QUAD CITIES UNITS 1 & 2 INDIVIDUAL PLANT EXAMINATION
TECHNICAL EVALUATION REPORT
(FRONT-END)

Quad Cities 1 and 2
Technical Evaluation Report
on the Individual Plant Examination
Front End Analysis

NRC-04-91-066, Task 21

Science and Engineering Associates, Inc.

Figure II-1. CDF by Initiating Event for Quad Cities

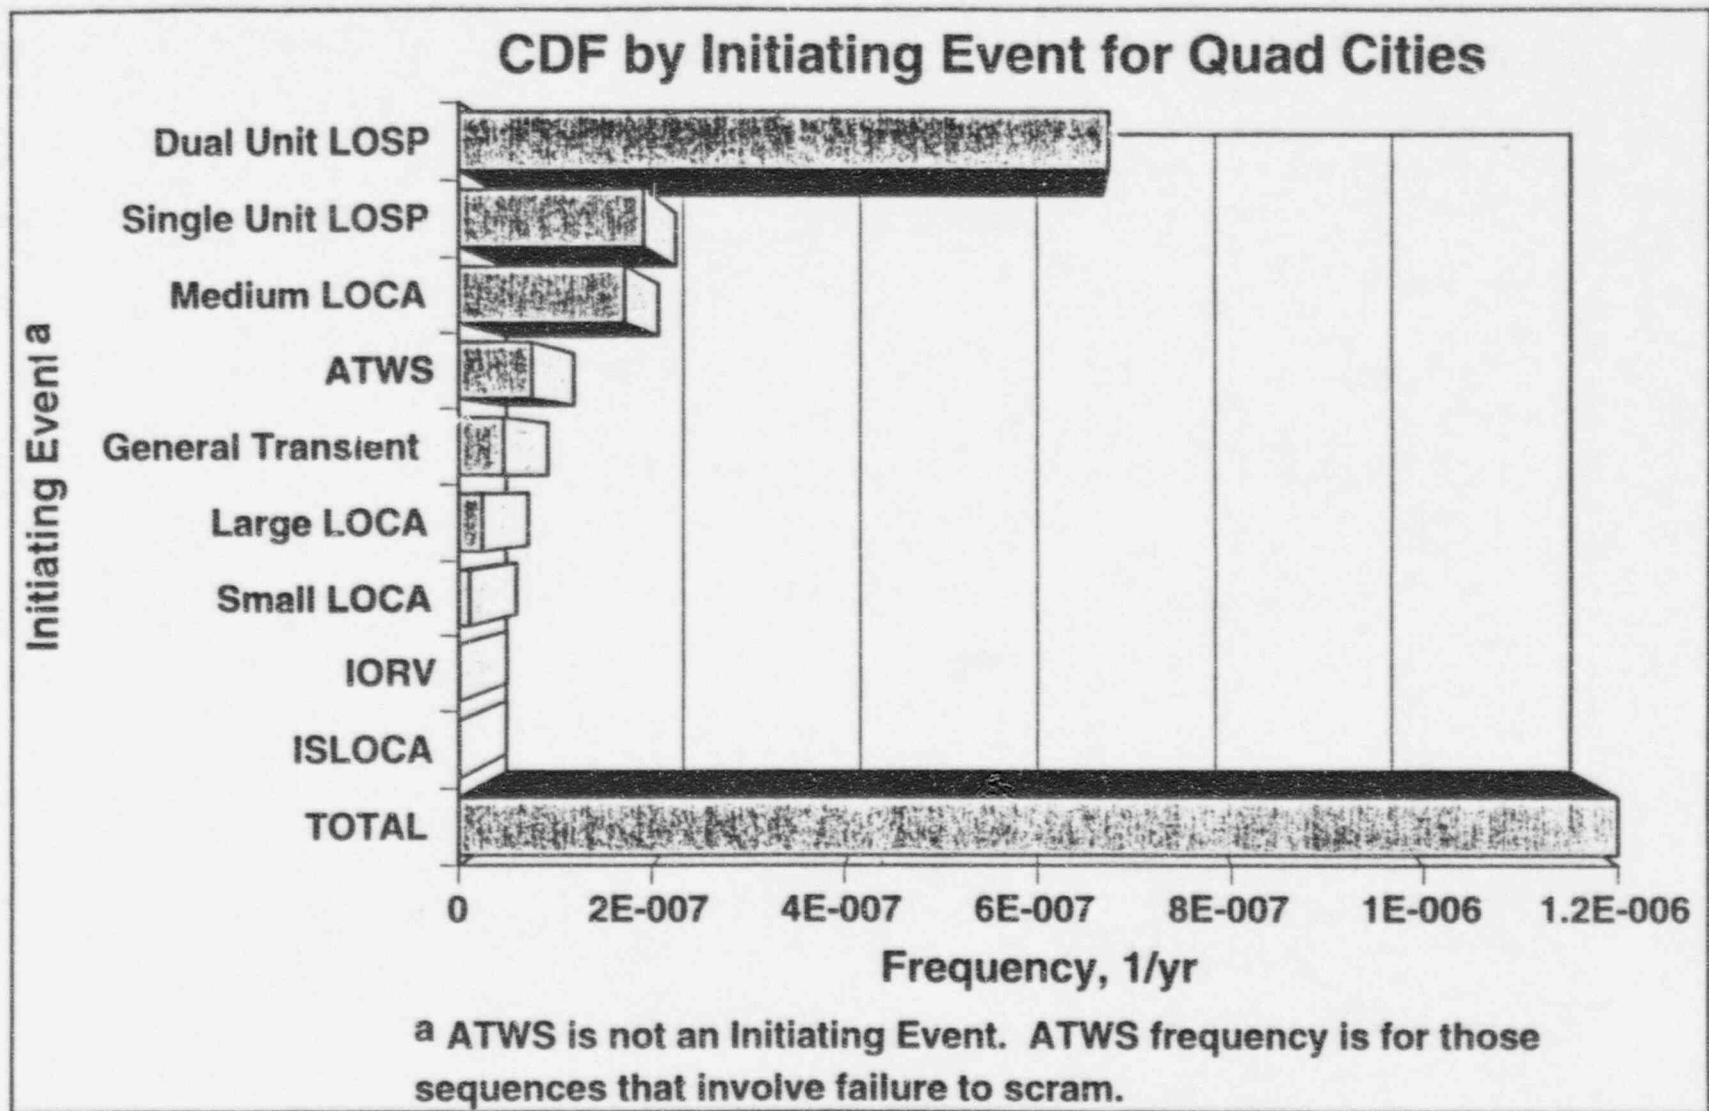
Figure II-1 of this report summarizes the major contributors to core damage by internal initiating event. These results apply to each of the two units. Definitions of the acronyms and abbreviations used in this figure are as follows:

The total CDF from internal initiating events is $1.2E-6$ /year. Internal flooding was determined to be a negligible contributor.
